1954 Corvette: Service Bulletin: Connecting Rods

Subject: Connecting Rods

Bulletin No: DR-164

Date: January 13, 1954

**REWORKING 1953 POWERGLIDE ROD FOR
USE IN 1954 POWERGLIDE ENGINE**

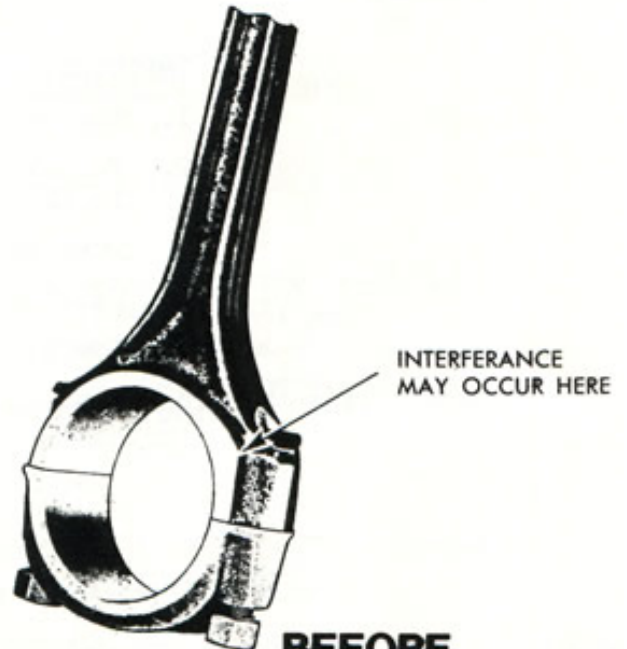
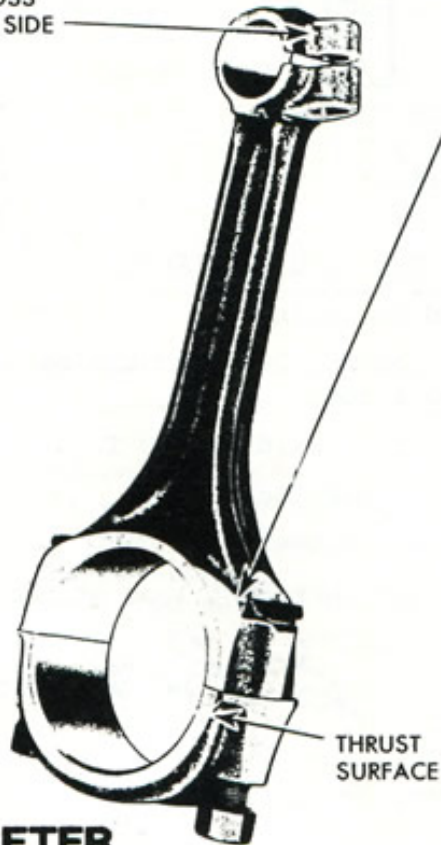
Until such time as the 1954 Passenger Car Powerglide Connecting Rods are available and it is necessary to replace a rod in a 1954 Powerglide Engine, the 1953 Powderglide Rod may be used after reworking.

if the 1953 Rod is not reworked, interference may occur between the new wide lobed (9/16") camshaft and the number 2, 4 and 6 rods on the camshaft side at the rear of the rod in the area at top of connecting rod bolt.

PINCH BOLT BOSS
TO CAMSHAFT SIDE

RELIEVE THIS AREA
BY GRINDING AS SHOWN.
GROUND AREA SHOULD BE
AT 30° WITH THRUST SURFACE
OF ROD-CAMSHAFT SIDE-REAR
ON NO. 2, NO. 4, NO. 6 RODS
